Subject: Minutes for 56th Protection Sub-Committee Meeting.

56th Protection Sub-Committee Meeting (20th January, 2025)-MoM

**Minutes of
56th Meeting of Protection Sub-Committee (PSC) of
Northern Regional Power Committee**

DR of 220kV CB Ganj-Sitarganj(end) ckt

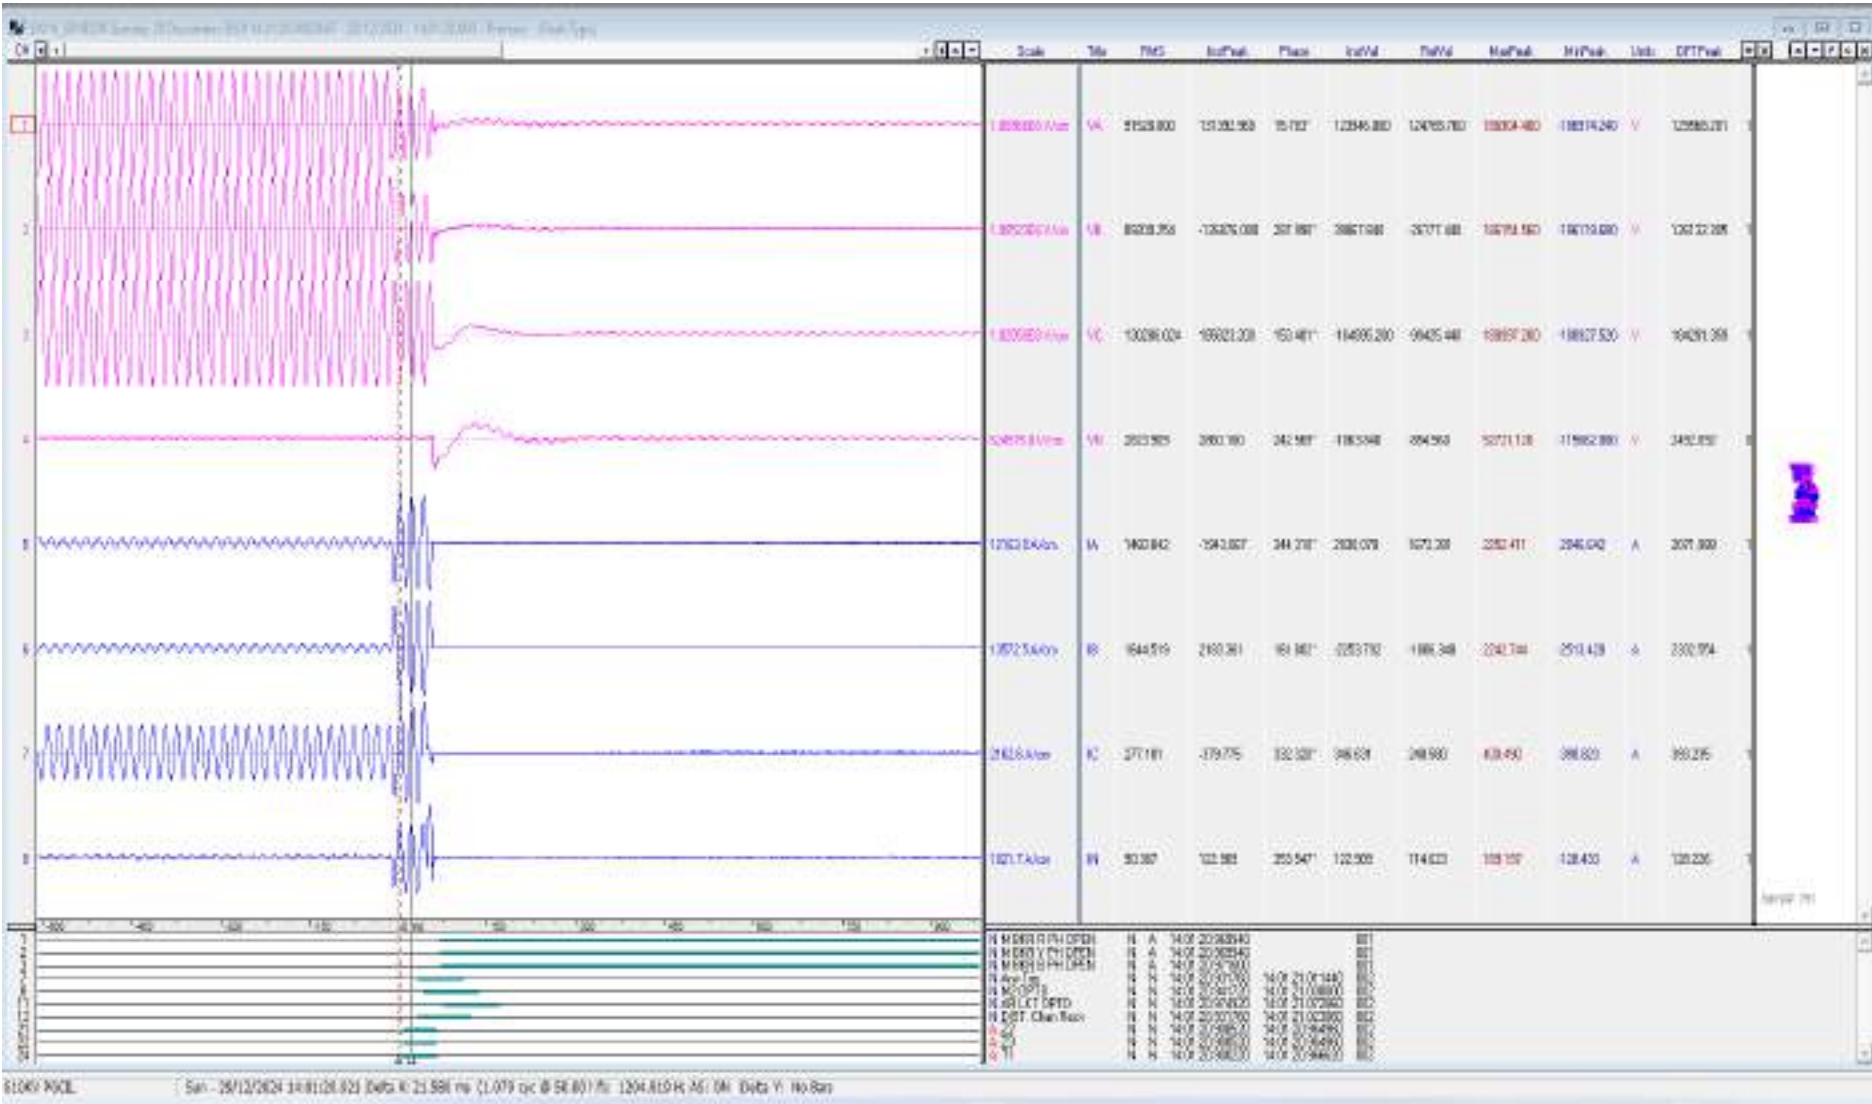
Fault clearance time: ~1280msec; R-Y fault was sensed in Z-2(99km, 95%). **Line tripped instantaneously**; Time also not synced

DR of 220kV Bassi (end)-Dausa ckt-1

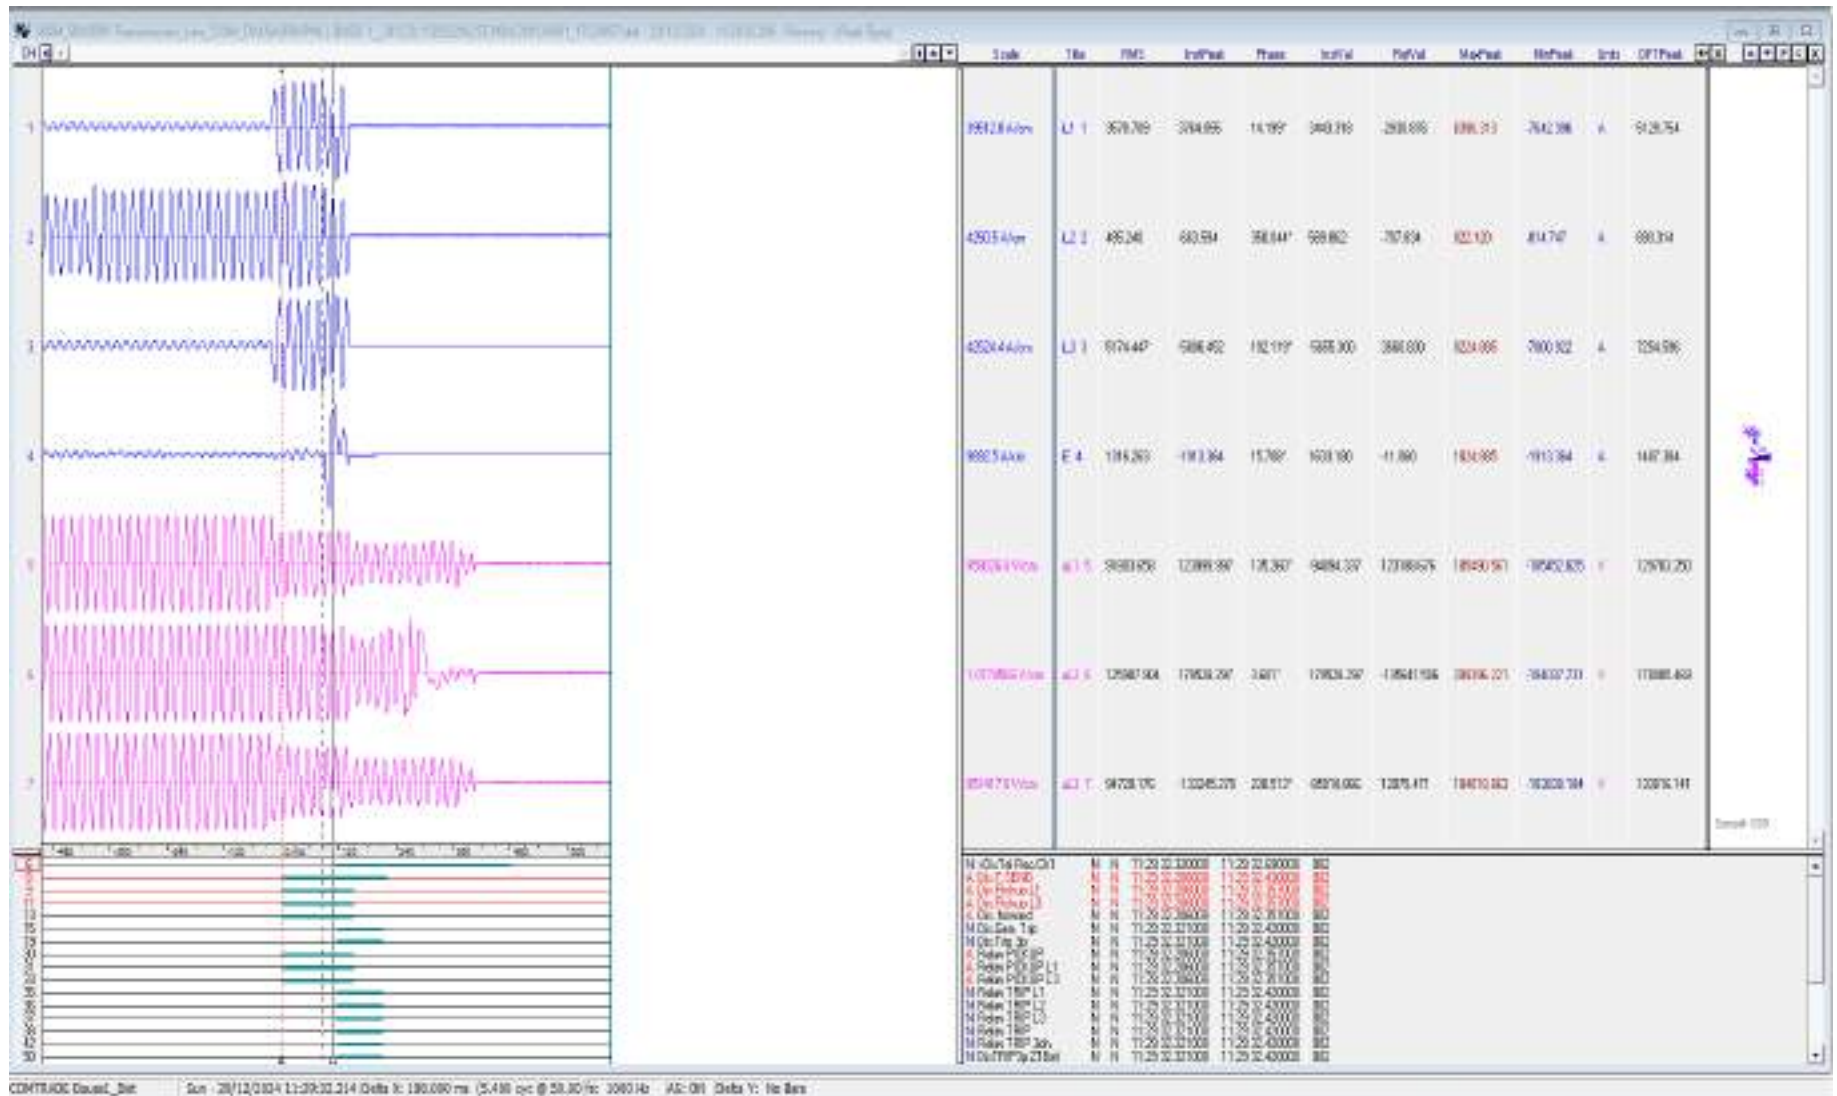
- R-B fault converted into R-B-N within 80msec
- R-B-N fault, 5.1kA
- Tripped from Bassi end after 120msec of fault initiation.

DR of 220kV Bassi (end)-Dausa ckt-2

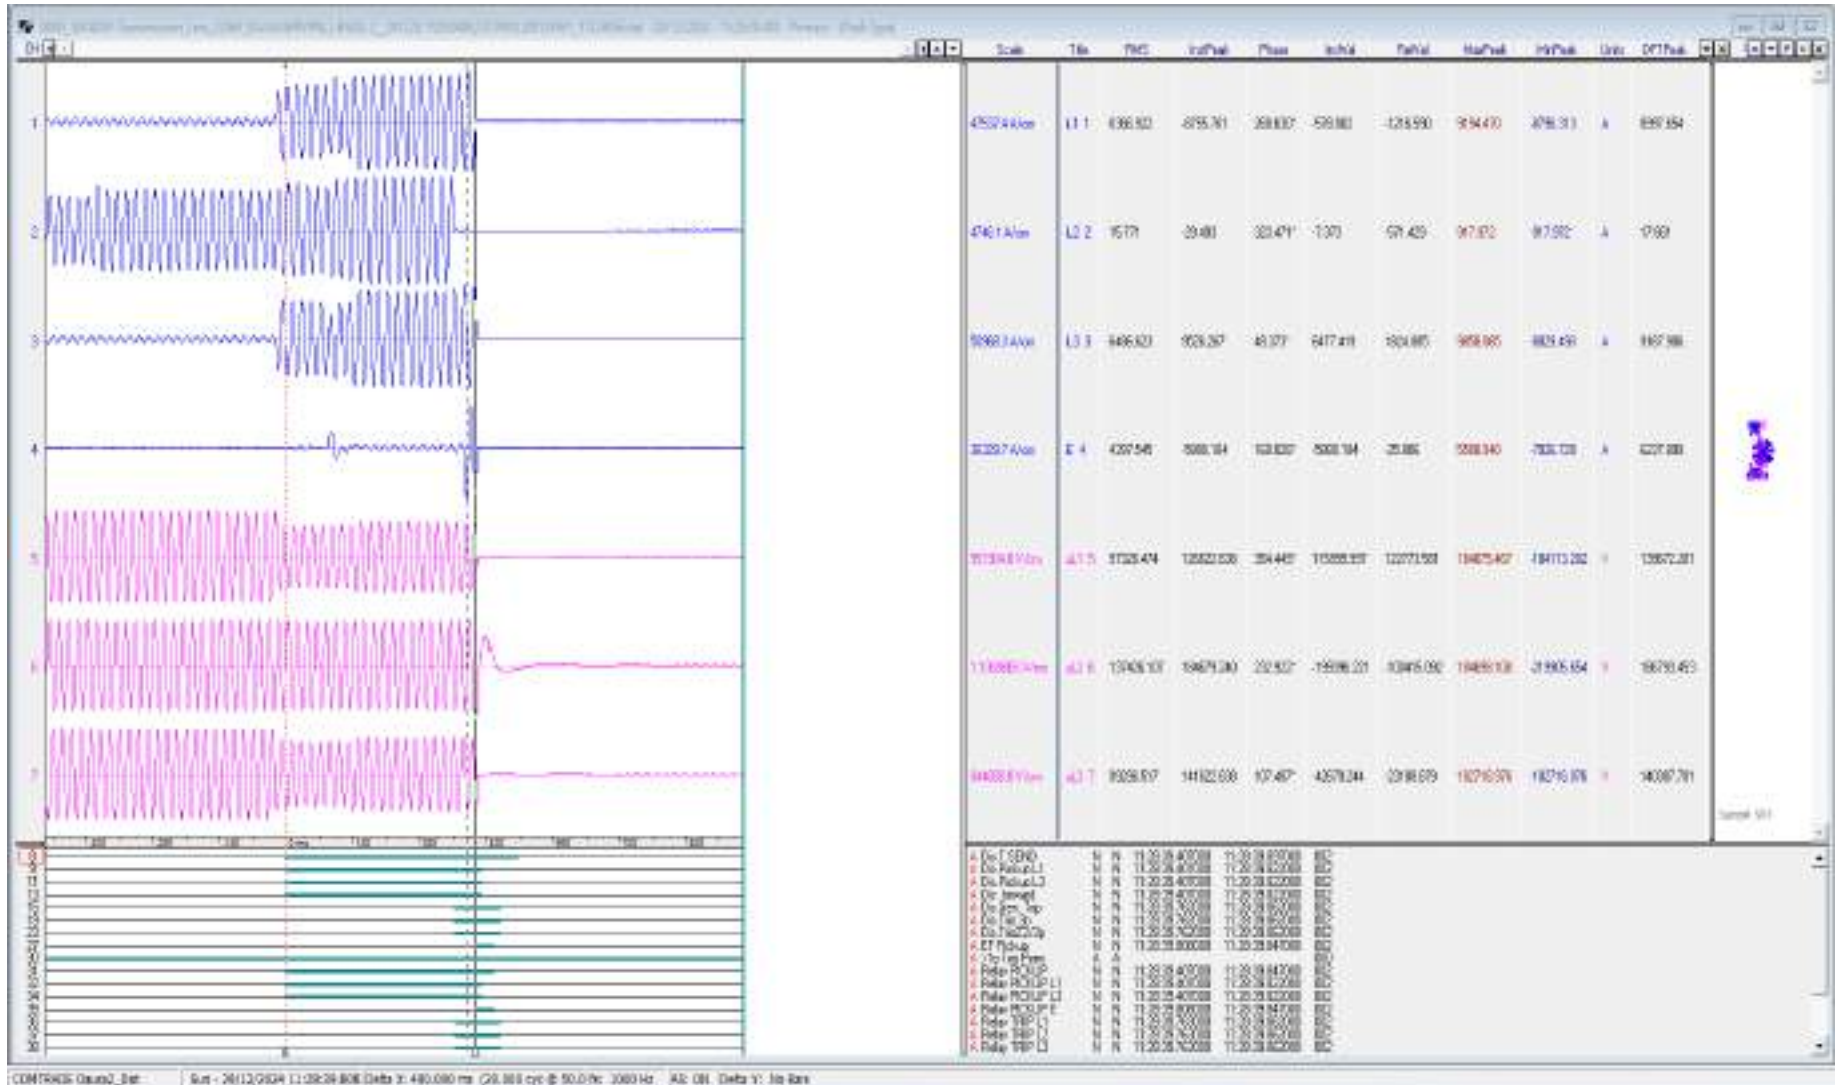
- R-B fault converted into R-B-N after 400msec
- R-B-N fault in Z-2, 6.39kA
- Tripped from Bassi end after 400msec of fault initiation.
